S90-09/10
1609.1.2.2, Chapter 35

Proposed Change as Submitted

Proponent: John Woestman, The Kellen Company, representing the Door Safety Council (DSC)

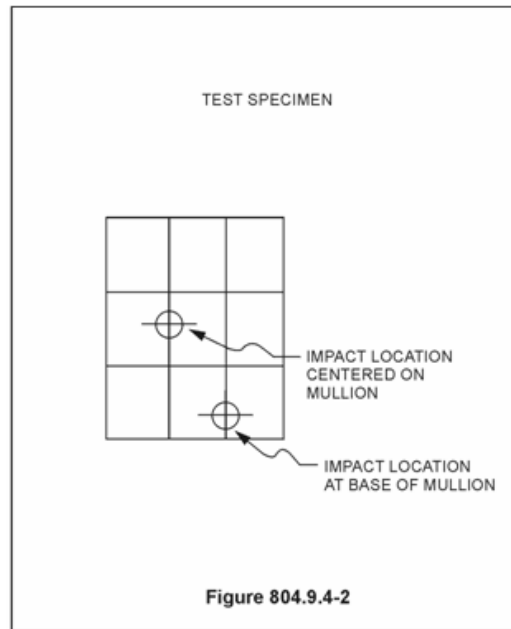
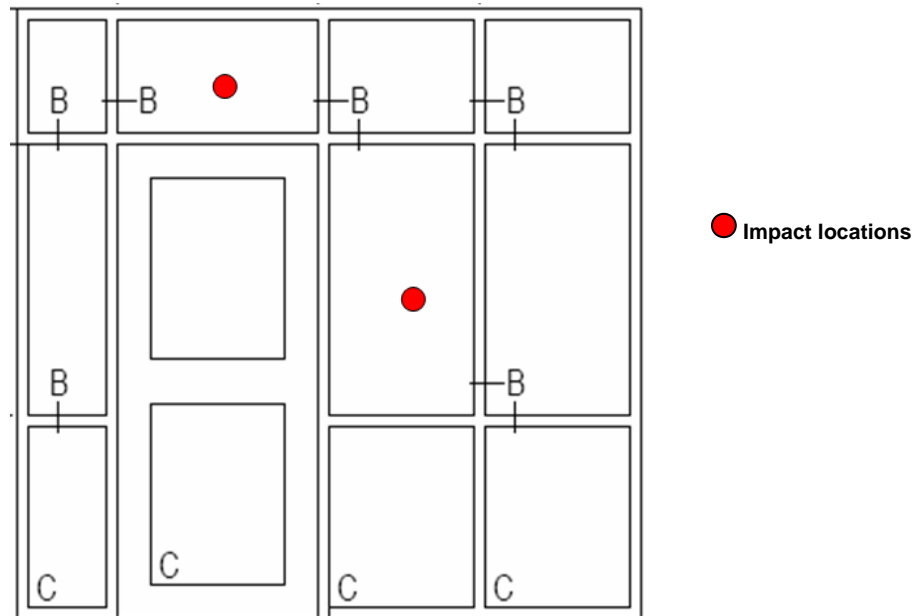
ANSI A250.13 - 2008 section 10.1 prohibits missile impacts to framing members of glazed transom / sidelite openings, as is typically conducted under ASTM 1996, ICC 500 or Florida Building Code protocol TAS 201 testing. A graphic comparison of impact test methods follows;

6.3.2.2 When testing any specimen with more than one component, in addition to complying with the impacts required by Section 1626.2 of the Florida Building Code, the framing member connecting these components shall be impacted at one half the span of such member with the large missile at a speed indicated in Section 1626.2.4 of the Florida Building Code.

804.9.4 Windows and other Glazed Openings. All window assemblies and other glazed openings shall be impacted in the center of the smallest glazed section, and at one interface corner as detailed in Figure 804.9.4-1. Where interior mullions or other glazed section joints and/or latches are present, additional impacts shall be applied on these features as shown in Figure 804.9.4-2.

1613.5.1, Figure 1613.5(1) - Figure 1613.5(14)

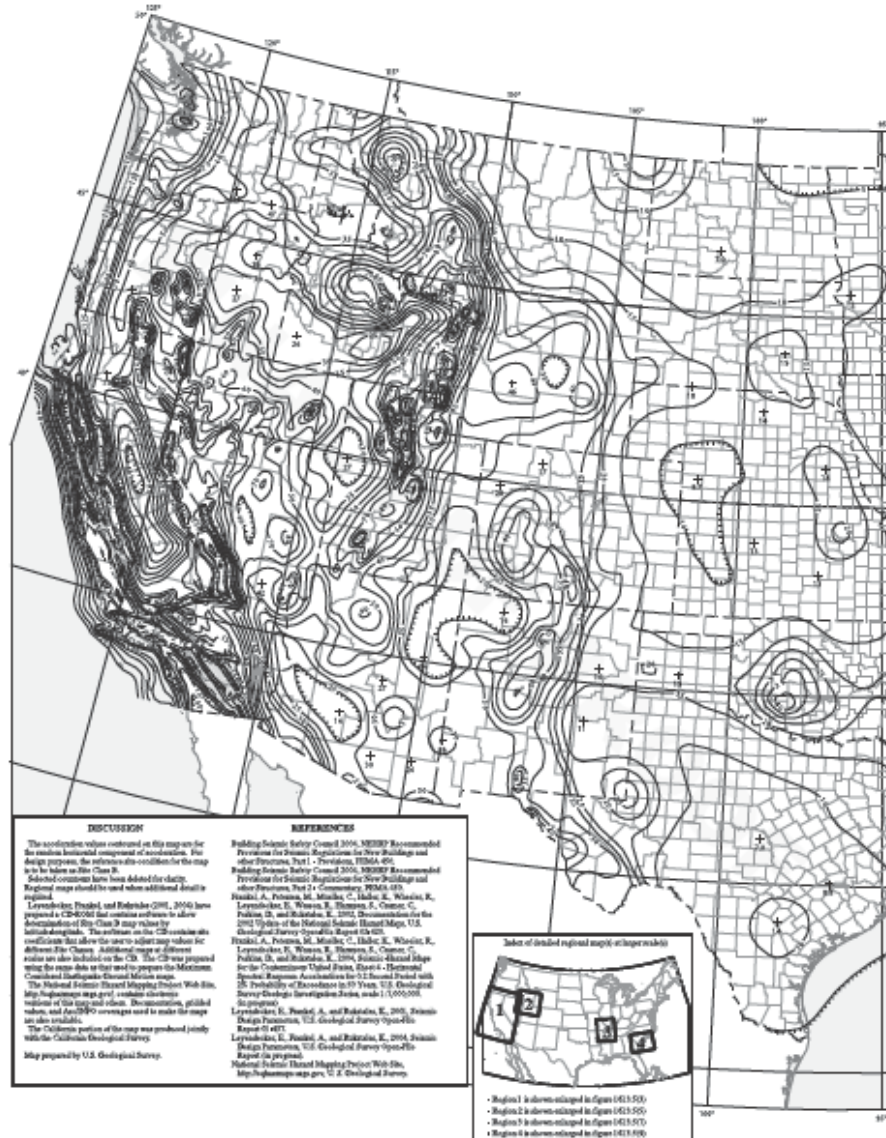
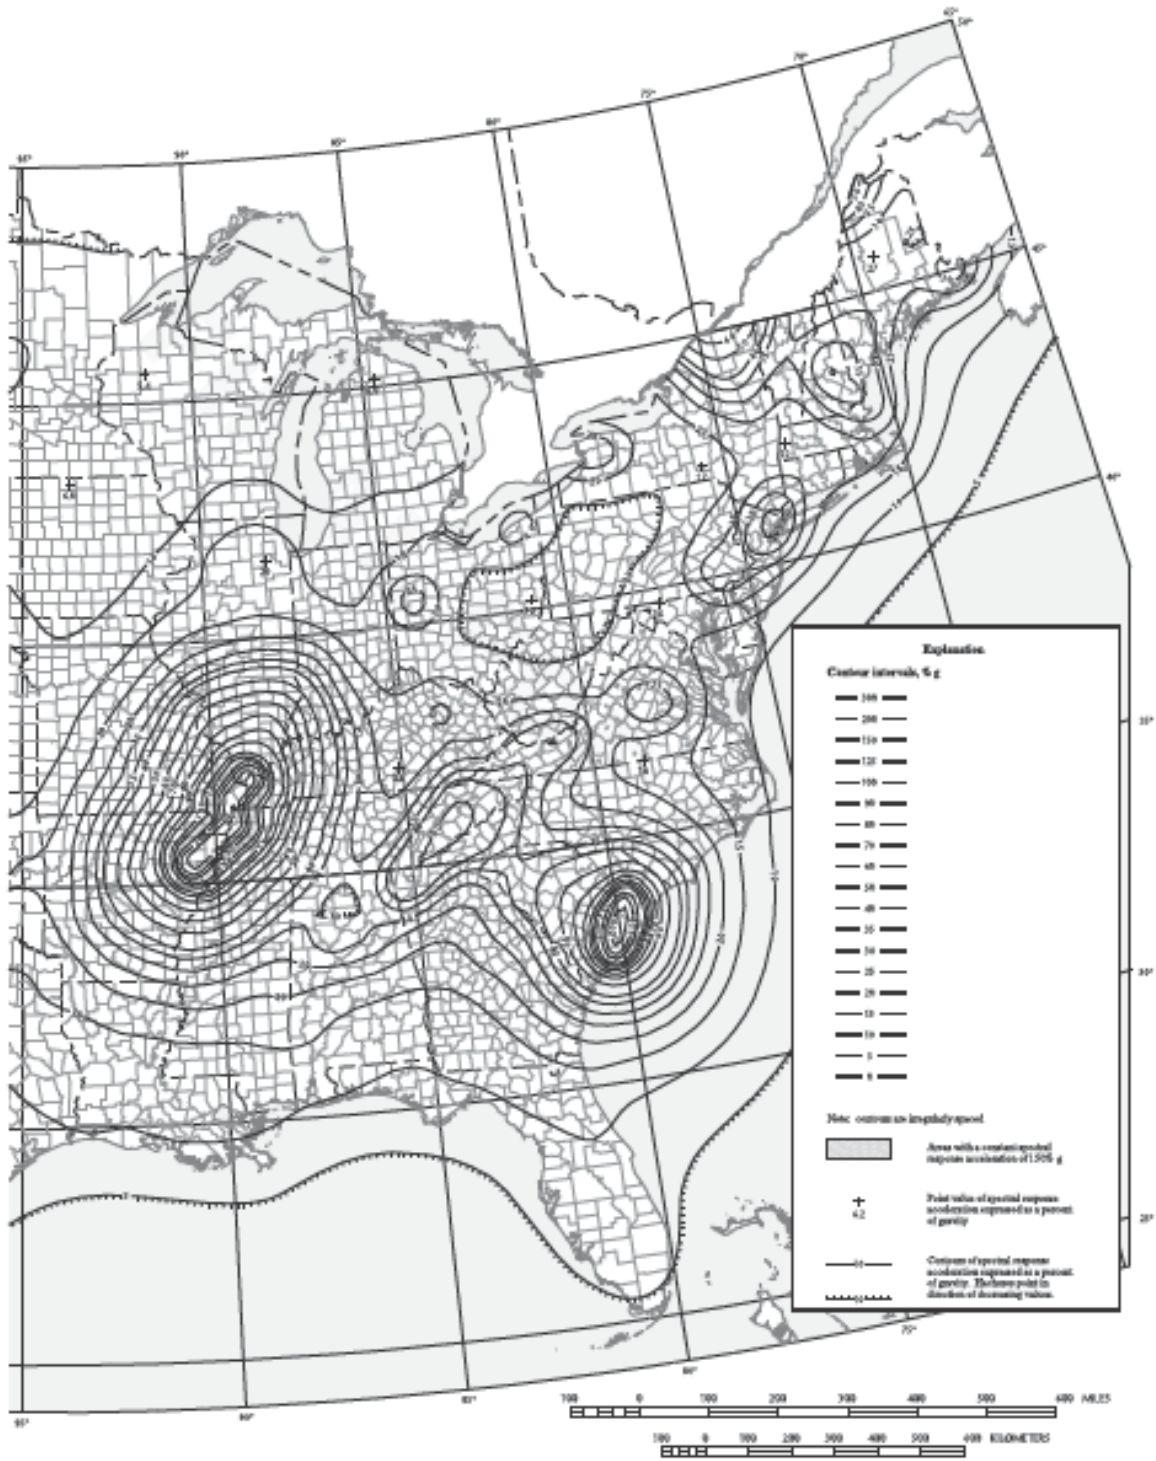
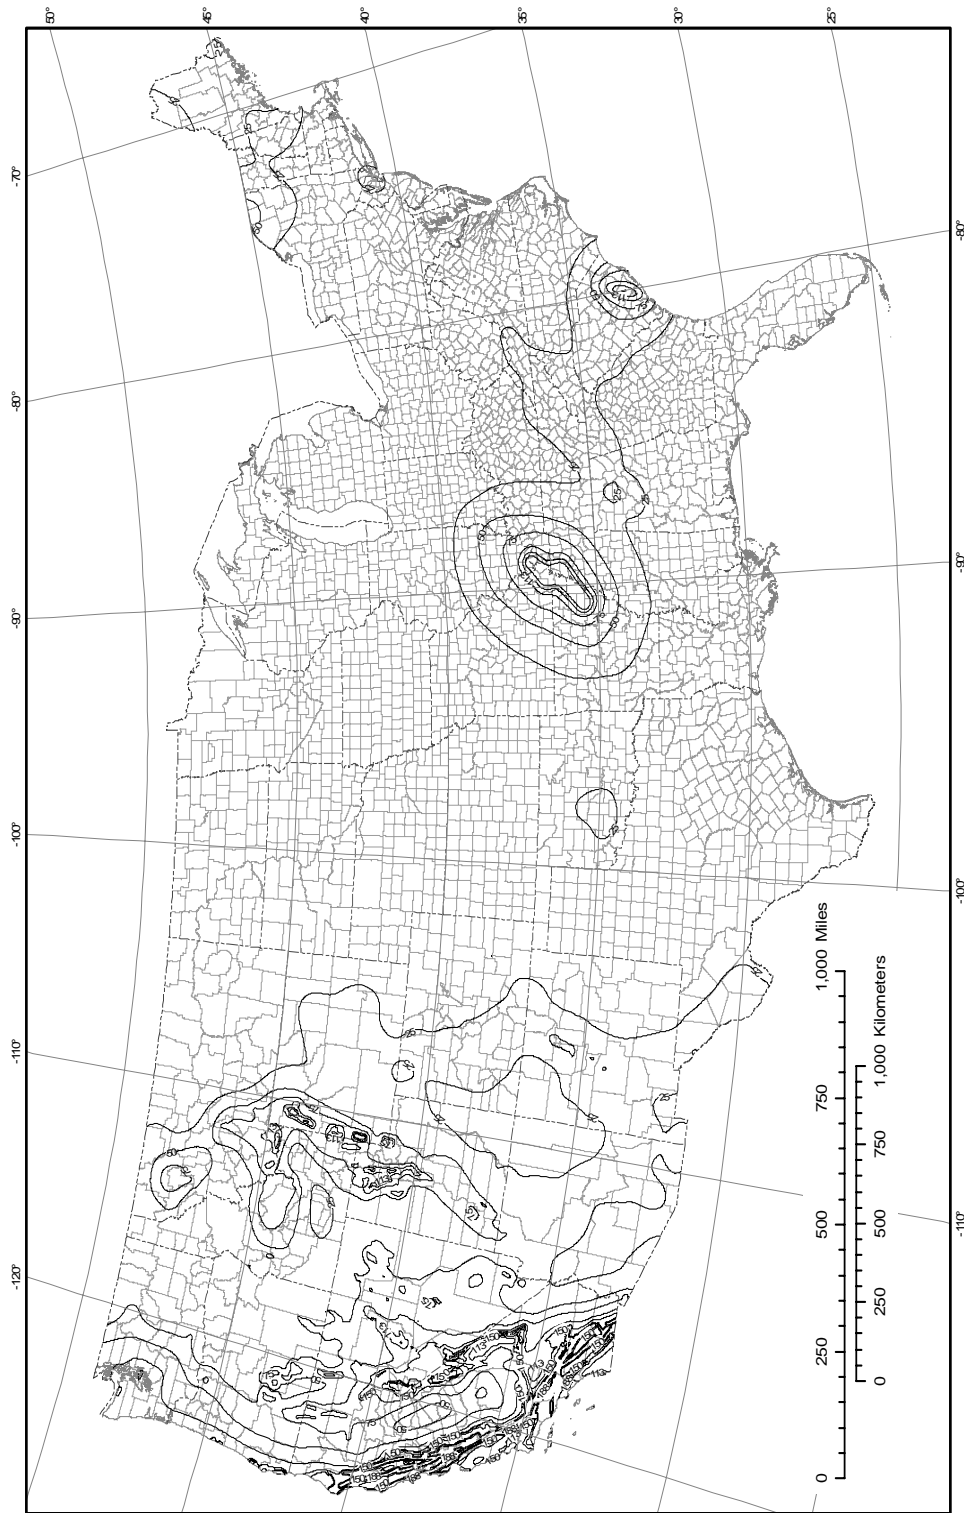
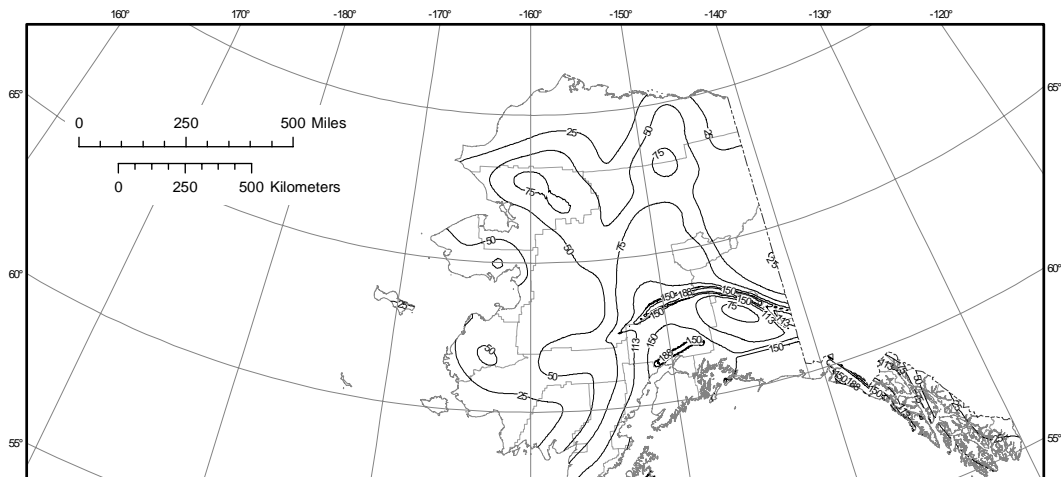
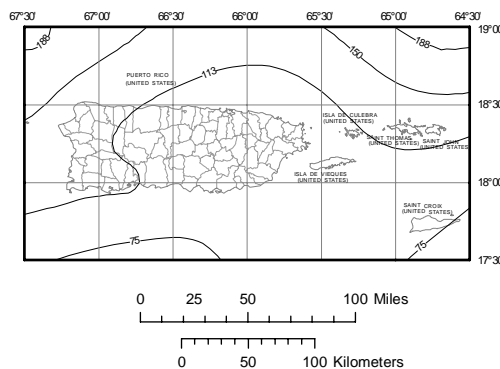
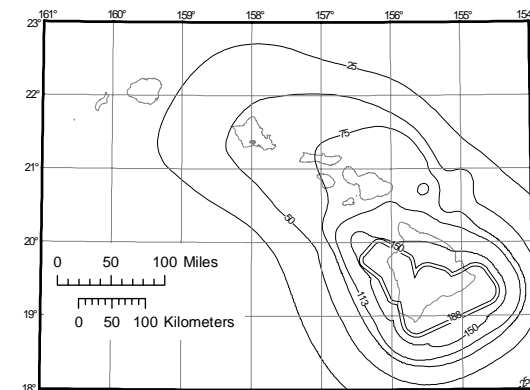
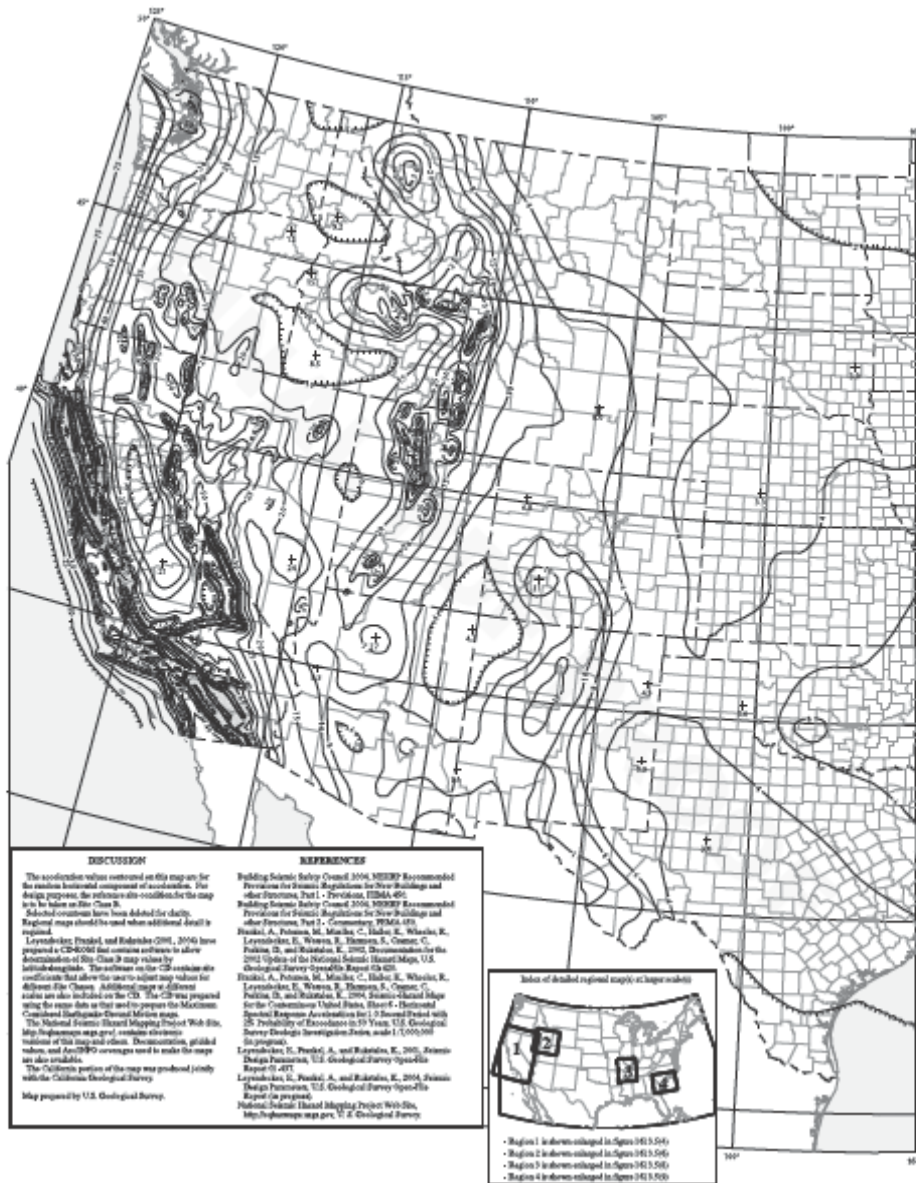
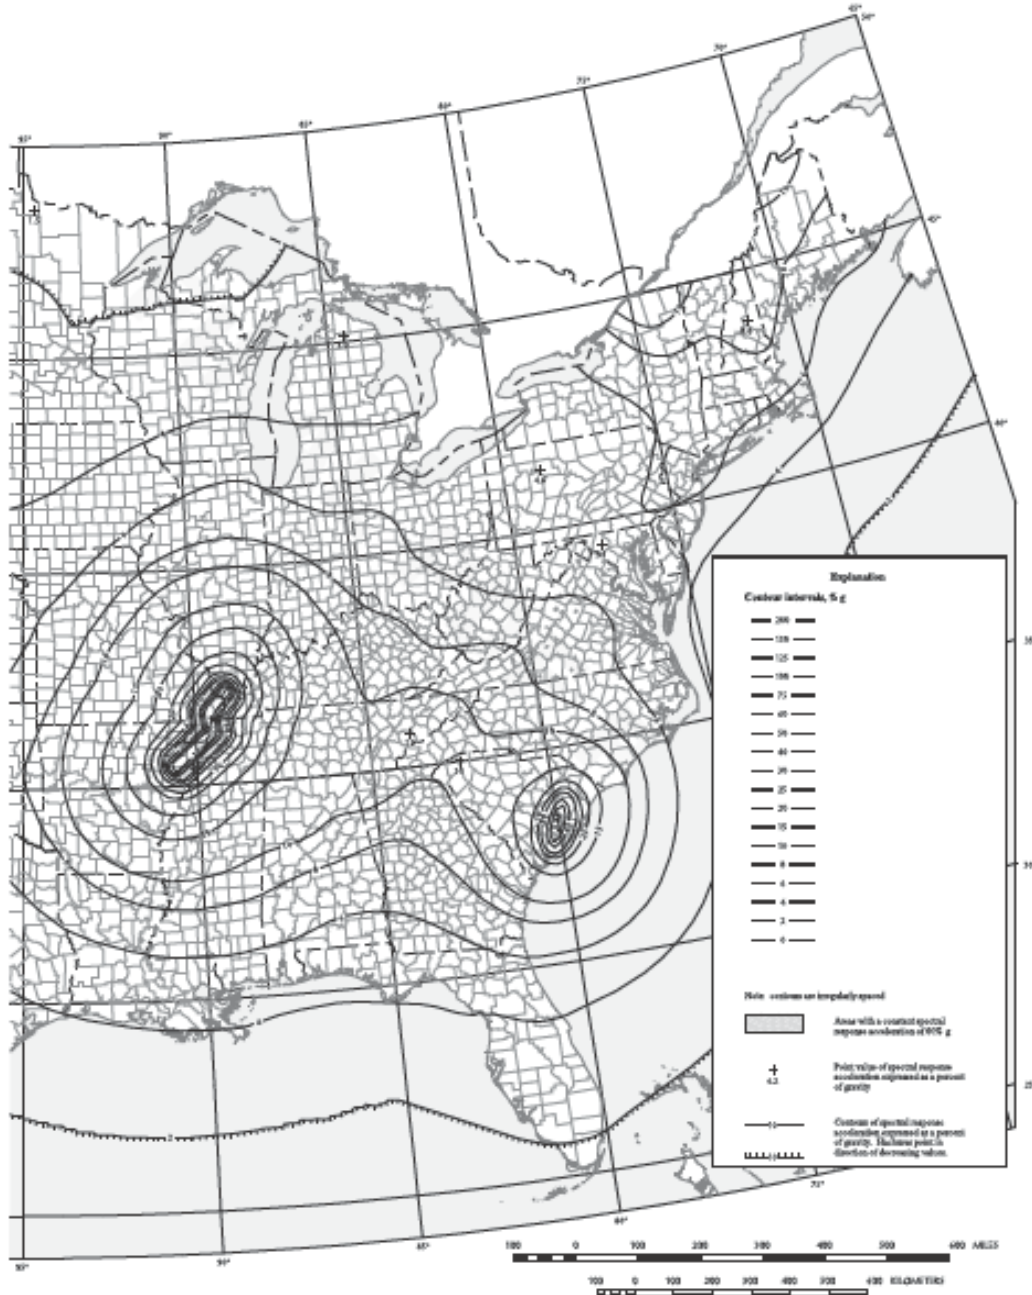
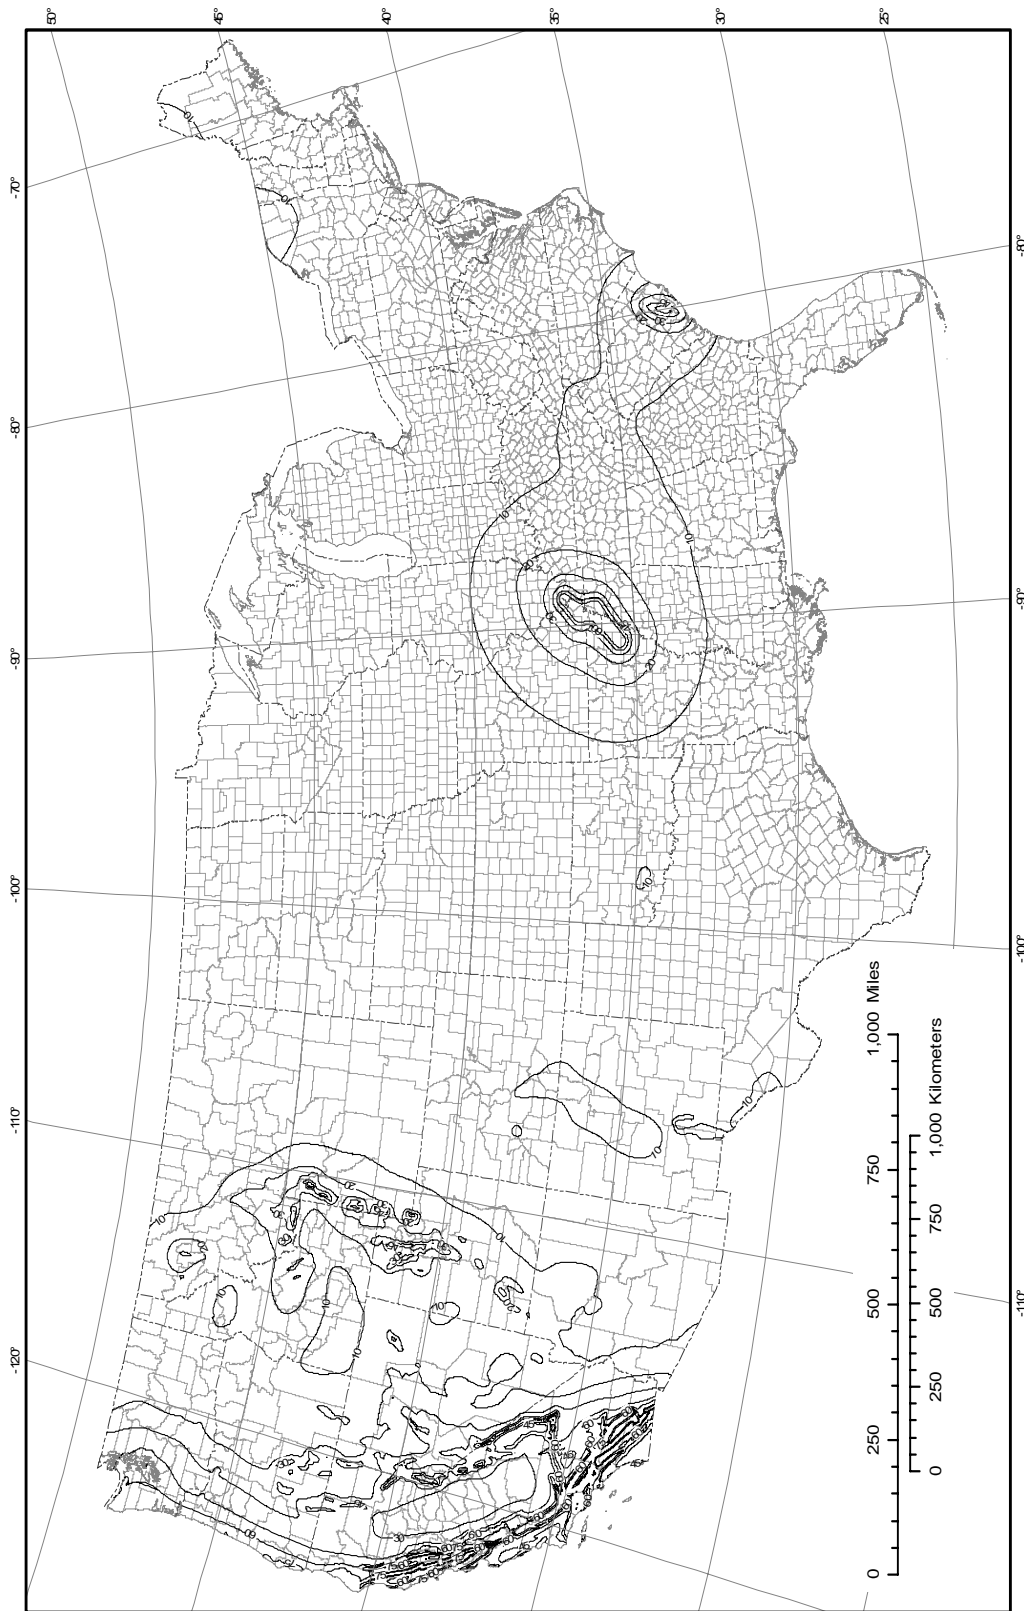
The proposed ground motion maps for the IBC also reflect a current draft proposal for change to the ASCE 7 (Minimum Design Loads for Buildings and other Structures) standard update process. Under normal circumstances, ASCE 7 would adopt ground motion map related changes drawn from the most current edition of the *NEHRP Recommended Seismic Provisions* prior to incorporation of the maps into the IBC; however, the recent changes to the ICC code development process and schedule have made it necessary to submit this working version of the ASCE 7 proposal in an effort to provide the regulatory community with the most up-to-date information available. It should be understood that, to the extent possible, this proposal will be updated to reflect any modifications to maps, maps titles or other Section 1613 content made during the ASCE 7 consensus standard process so the consistency between ASCE 7 and the IBC is maintained. In the NEHRP update process the title for these maps was revised from "Maximum Considered Earthquake (MCE) Ground Motions" to "Risk-Targeted Earthquake (RTE) Ground Motions." This proposal retains the MCE terminology because it is retained in the working version of the ASCE 7 proposal.

This proposal also reduces the number of printed maps to appear in the IBC from 14 to 2. Twelve of the maps included in earlier editions of the IBC provided enlargements of portions of two maps that covered the entire United States; this proposal eliminates the enlargements. This is being recommended because the maps printed in former editions of the IBC, while generally illustrative of the earthquake hazard, could not be read clearly enough to provide exact design values for specific building sites. Those in need of precise design values can easily obtain them from a USGS web site (<http://earthquake.usgs.gov/research/hazmaps/design/index.php>) using the longitude and latitude of the building site, obtained from GPS mapping programs or web sites.

- (b) inclusive of *changes* in Mapped Spectral Response Acceleration contour values from previous code editions that were *not* specifically made clear (along with the impact of those changes on seismic design parameters).

- (c) inclusive of changes resulting from applying Next Generation Attenuation (NGA) relationships that reduced design spectral response acceleration by up to 25% in some earthquake prone regions of the country, despite a clear lack of consensus for this change from the USGS Ground Motion Mapping Workshop participants.

For the wholesale changes proposed here (where seismic hazard has become whatever input parameters people can come up with . . . from NGA, GPS strain monitoring, new faults and so-called slip rates, Risk mumbo-jumbo, generic fragility curves); the new spectral response acceleration maps should have first been produced in the same manner as the previous code editions - then a comparison of results could have been made with proposed applications of the new map. This is necessary for a reality check as to the reasonableness of adopting something “new” for “newness” sake, where it might weaken or reduce long accepted minimum standards for protecting the public safety.

These new maps should have provided a city-by-city comparison of old map design values with the “latest” to be considered values. Otherwise, there is no telling how the public safety is being impacted. Documentation of the discussions, votes taken, and specific explanations and justifications for these changes should have been provided to the committee and to the public. A code change proponent must be held accountable to justify these changes (and also clearly define these same) to the committee from which approval is sought. Giving a weblink to a telephone book of information is unacceptable for a public process.

Committee Reason: This proposal incorporates the latest USGS ground motion maps. The modification updates the map titles and provides reformatted versions of the maps with no technical changes. It also separates areas outside the conterminous United States, on individual maps.
